WATERLOO METRO QUARTER DEVELOPMENT

Site Plan

RTS Changes

Sheet title
General Arrangement Plan
Level 1 Plan

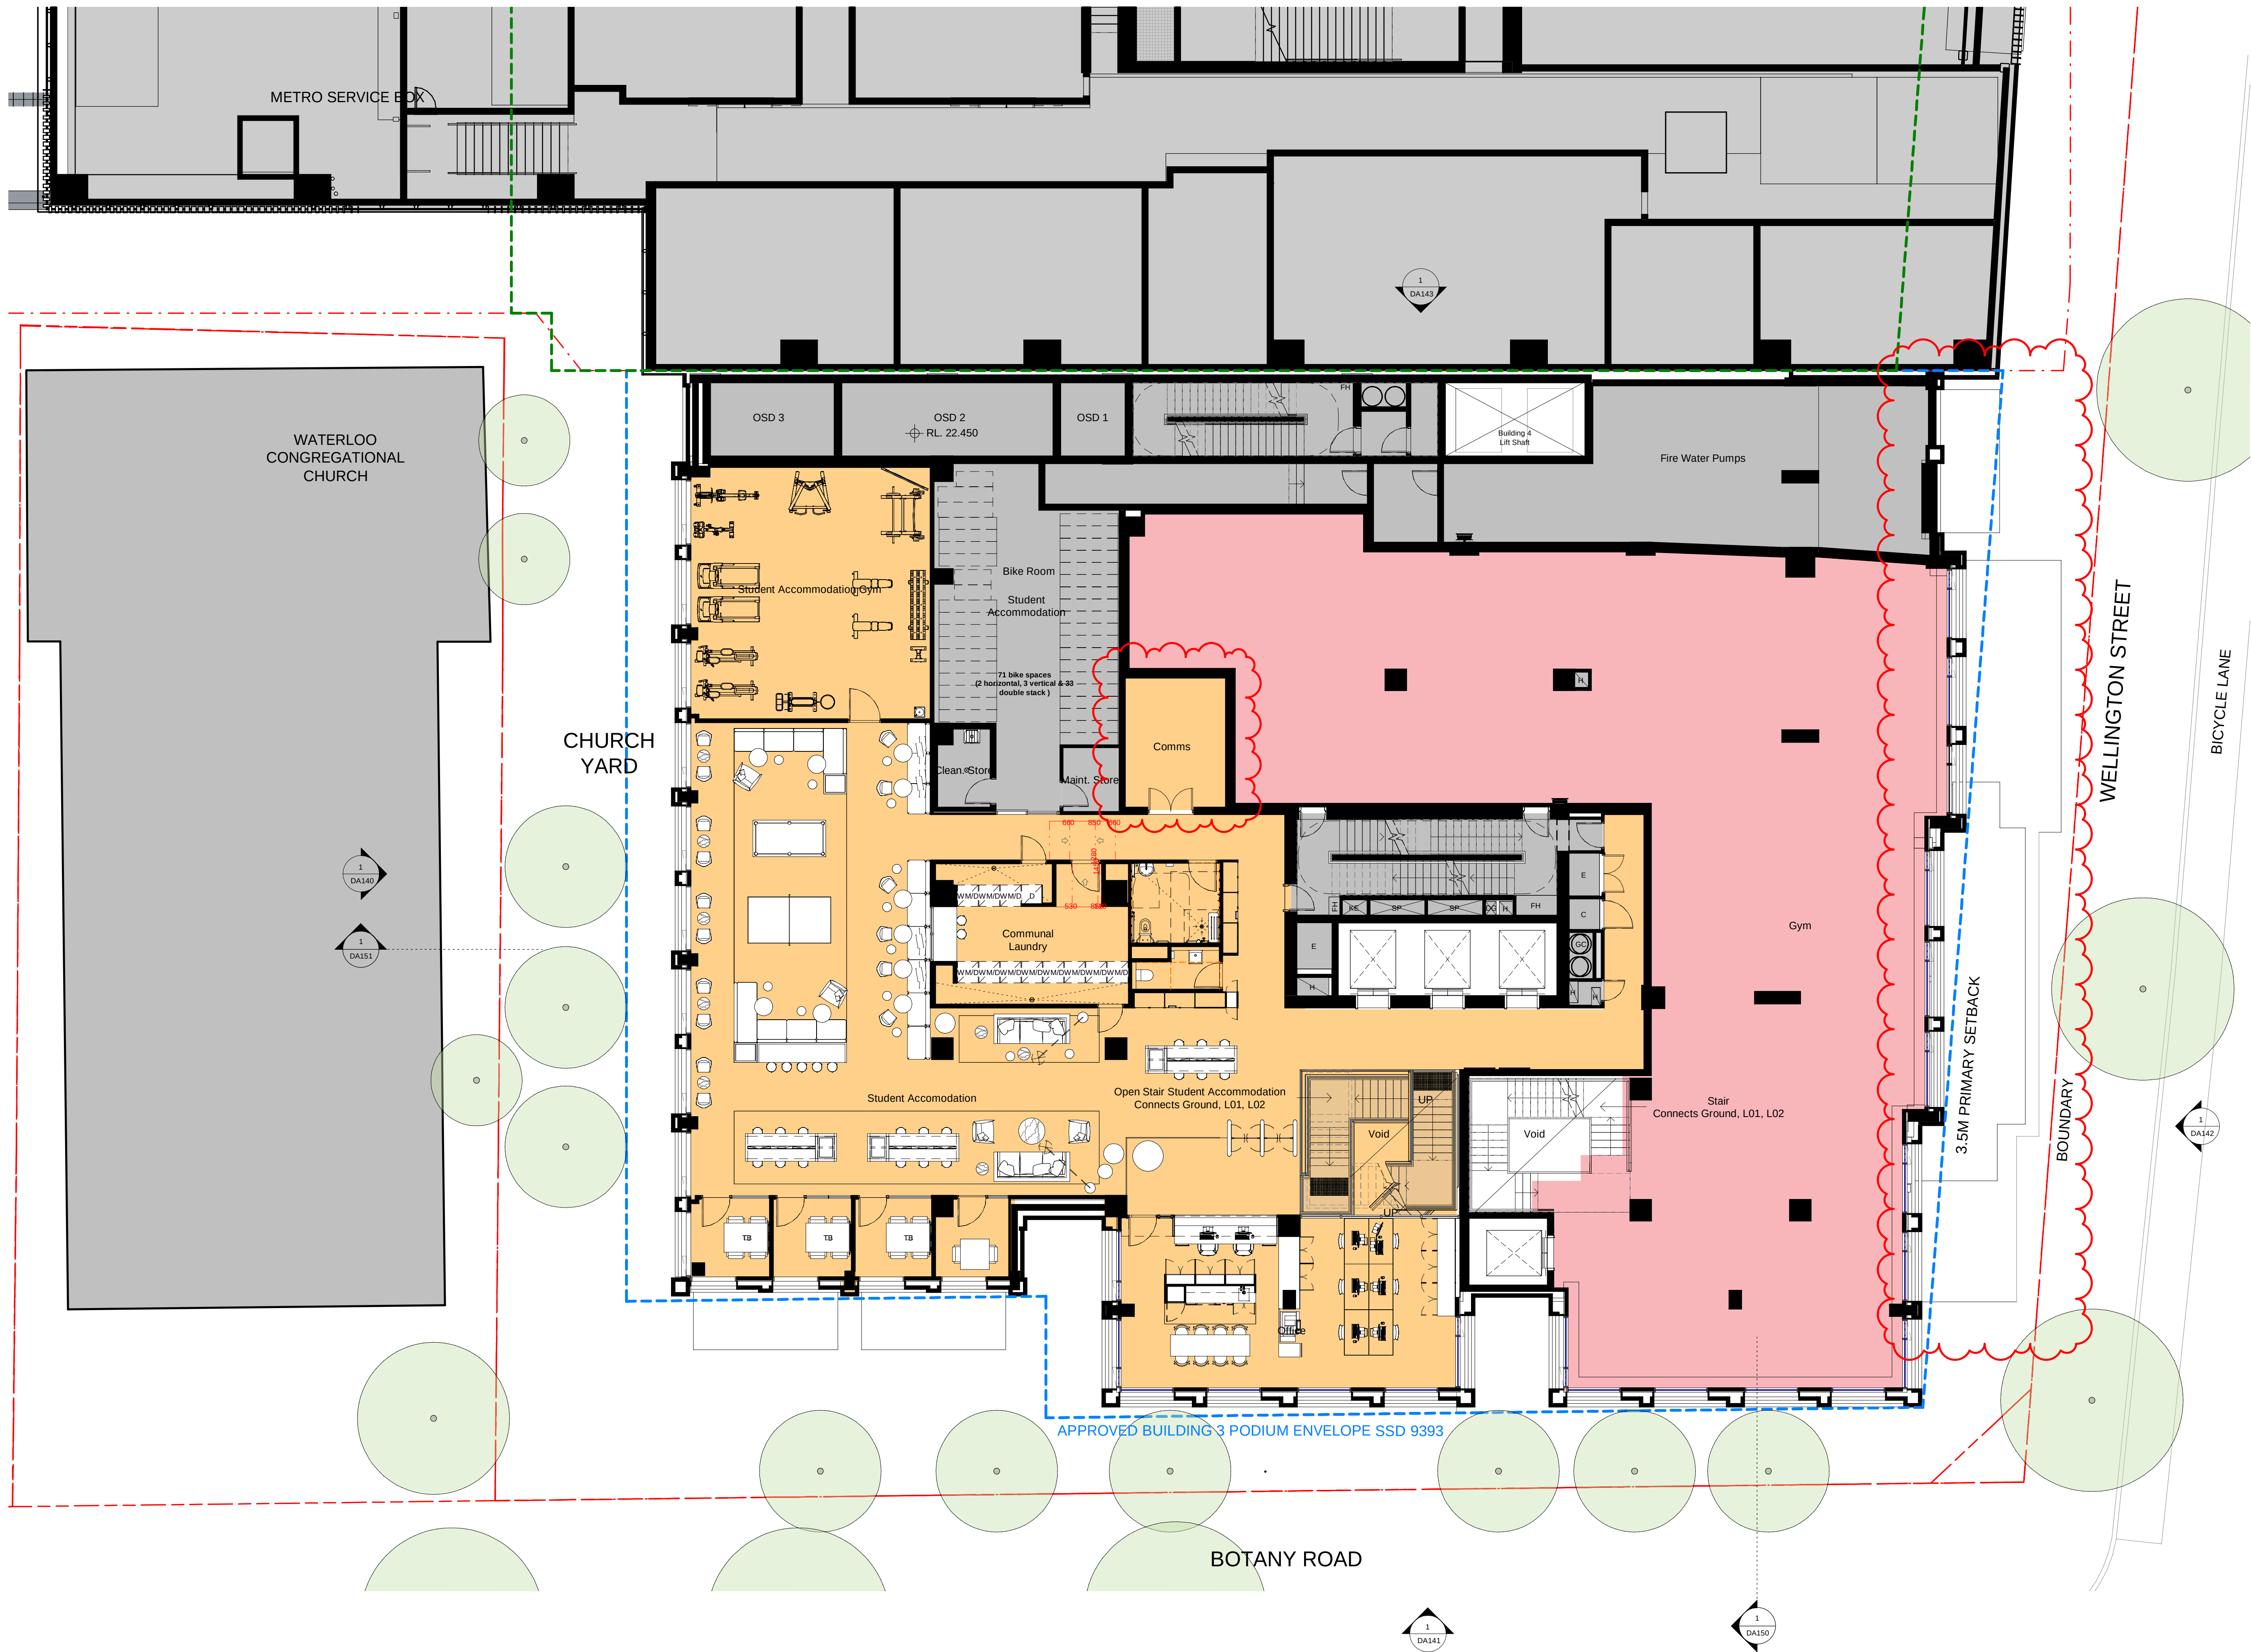
- RTS Changes
- Relocation of Comms Room from Level 2 to Level 1
 - Change to Podium Southern Facade and Awning

Sheet title
General Arrangement Plan
Level 2 Plan

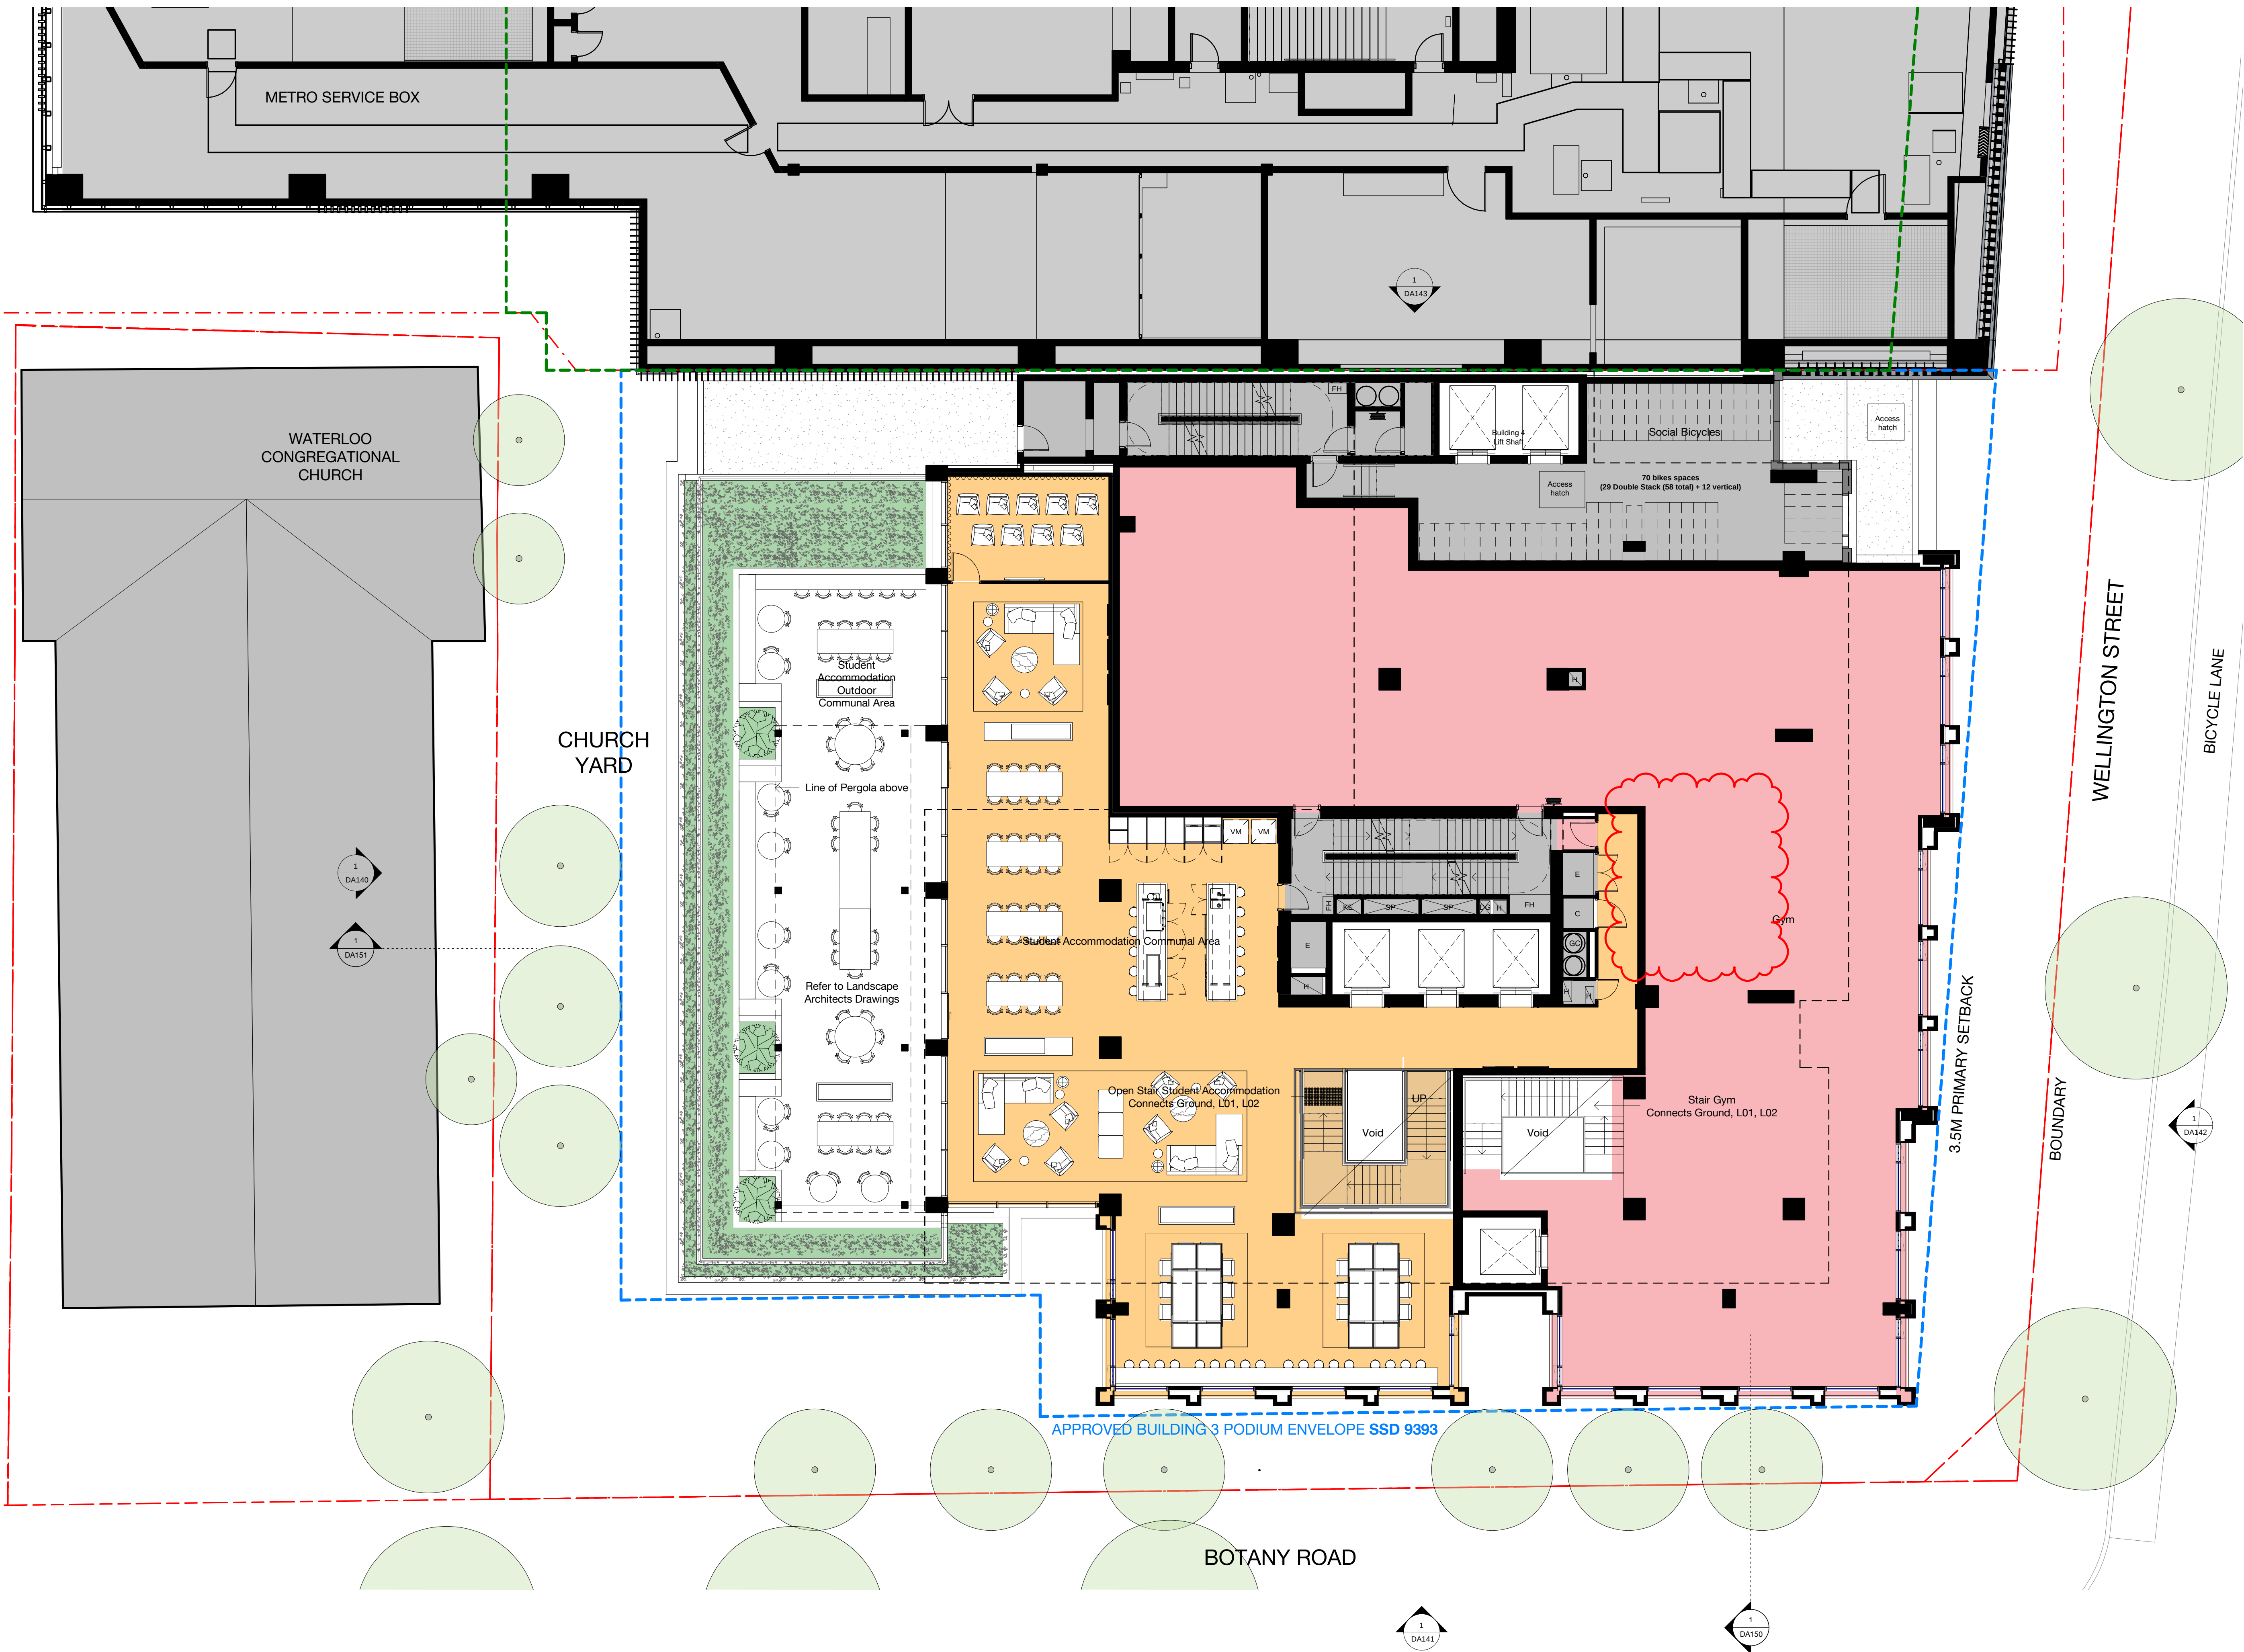
RTS Changes
• Relocation of Comms Room from Level 2 to Level 1

Sheet title
General Arrangement Plan
Level 3-5 Plan

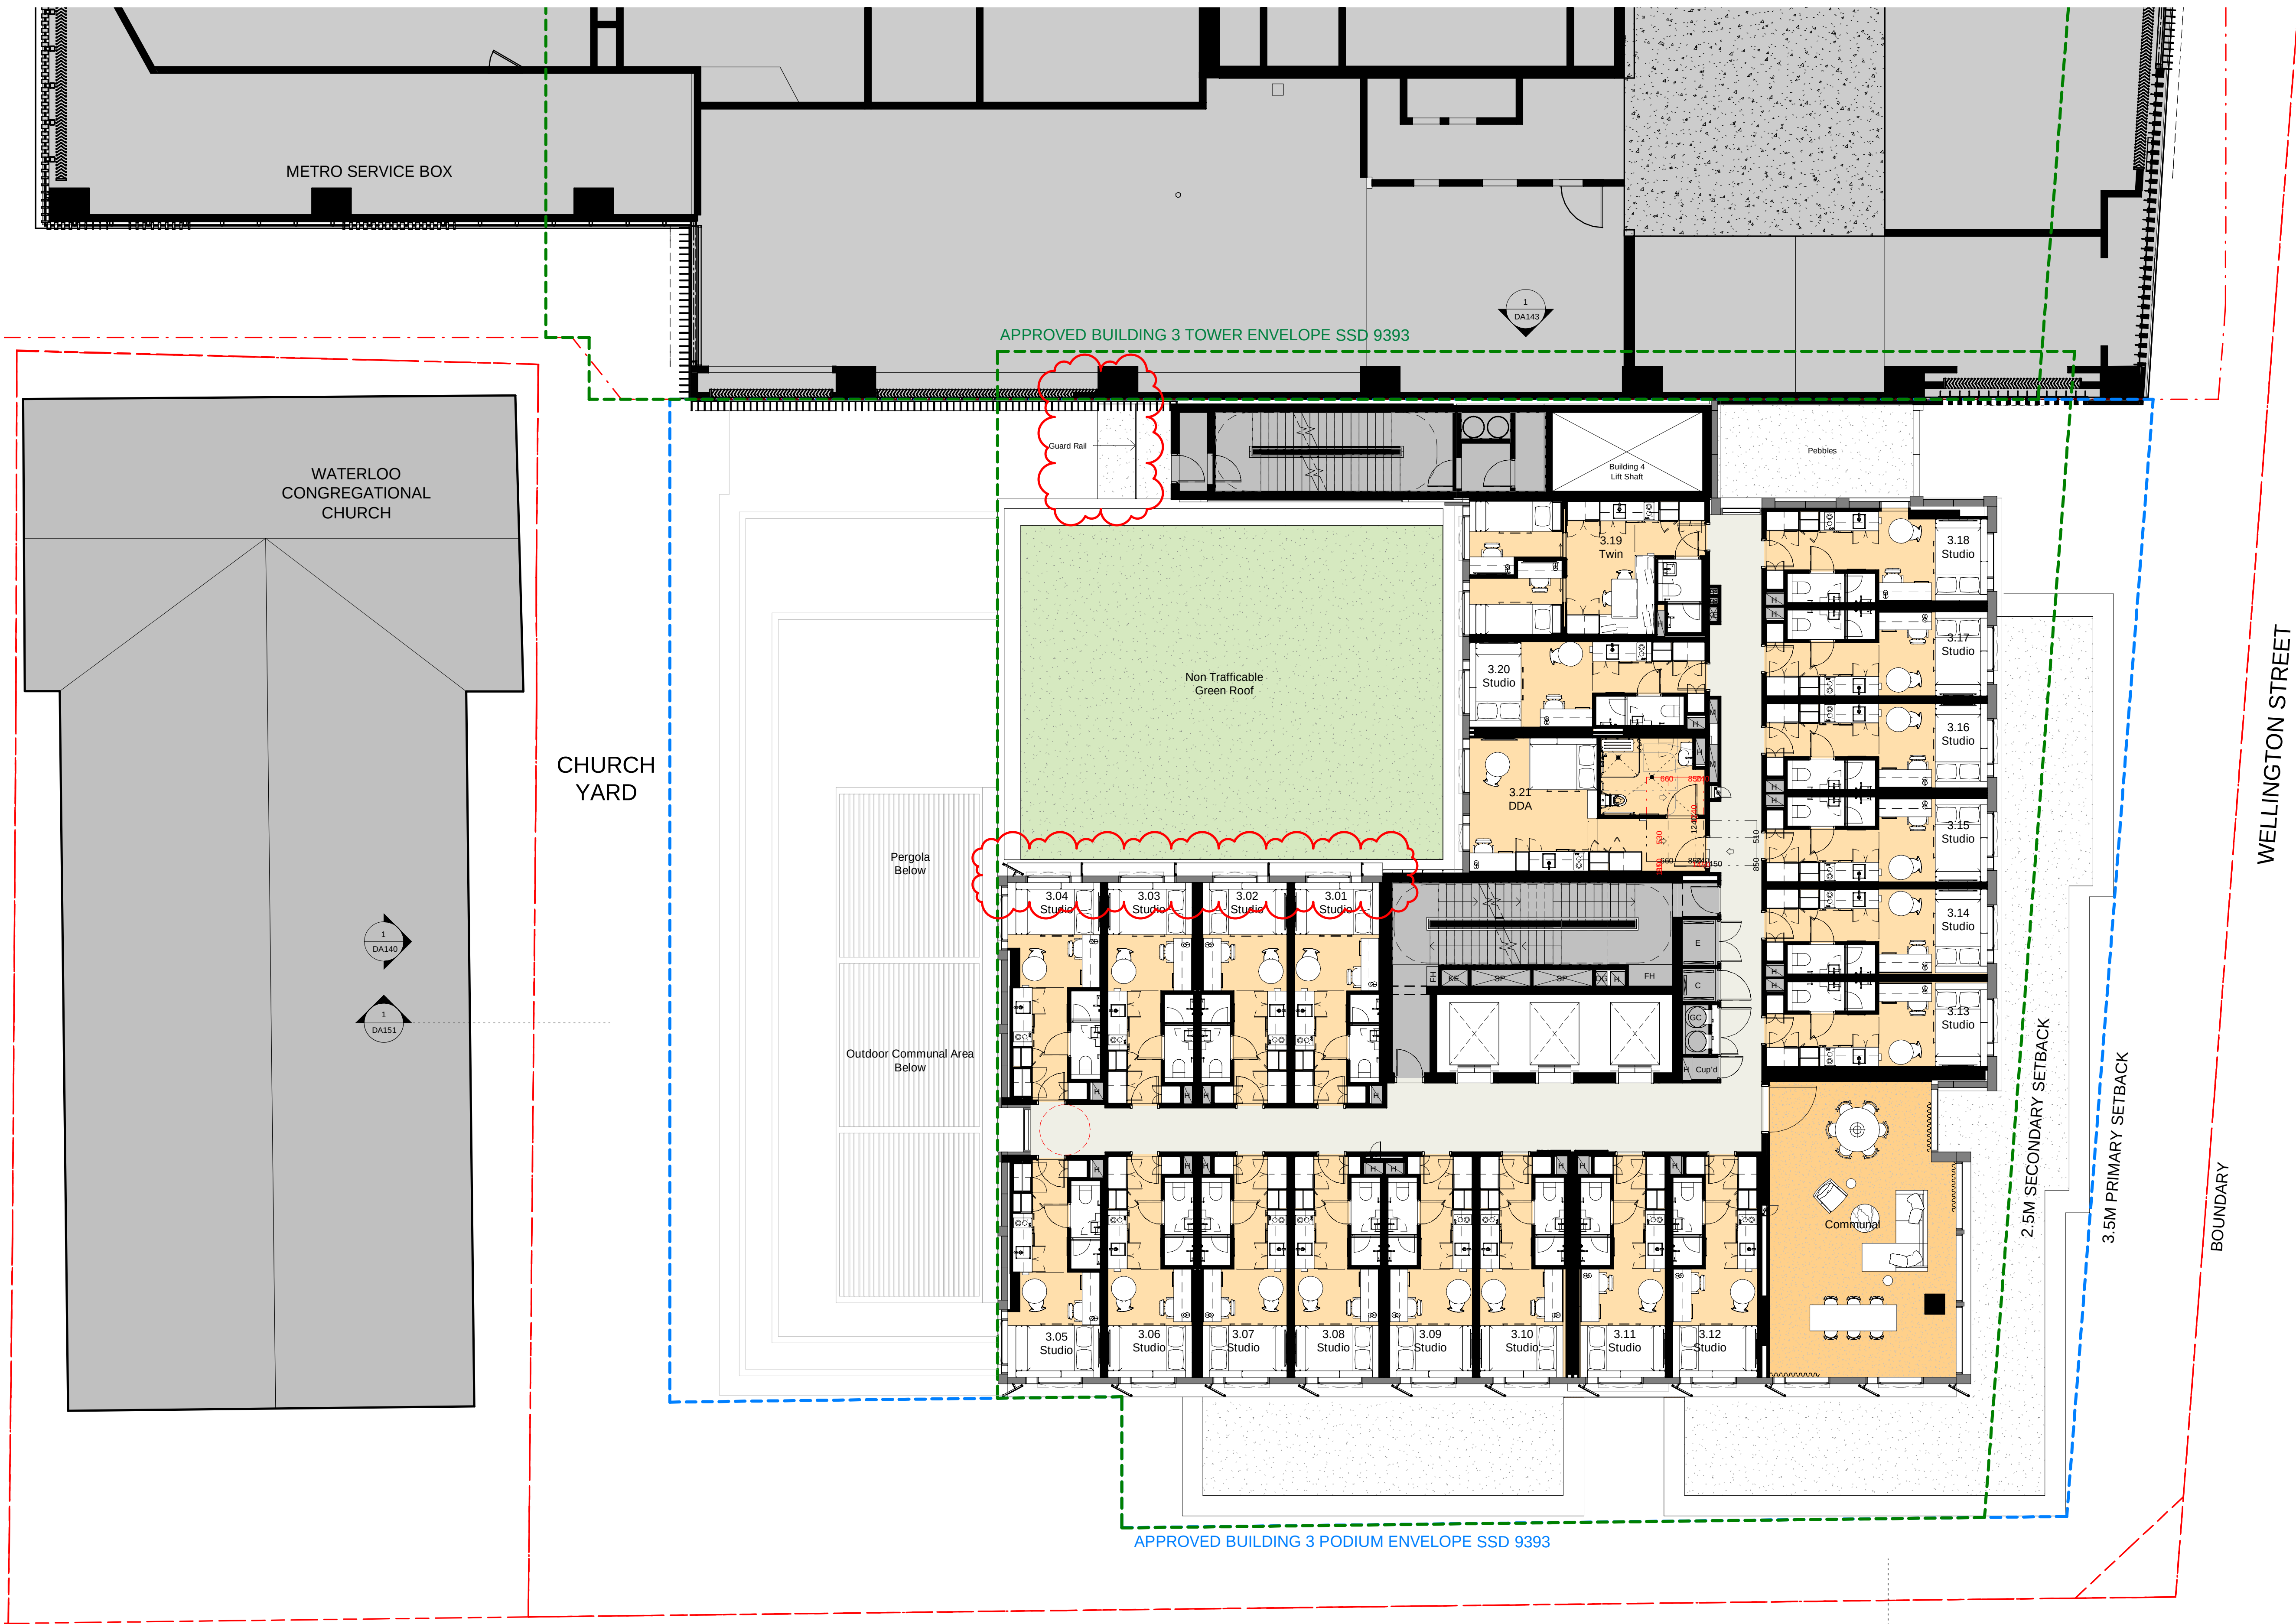
RTS Changes
• Change to Vertical Privacy Screen on Eastern Facade

Change to Vertical Privacy Screen on Eastern Facade
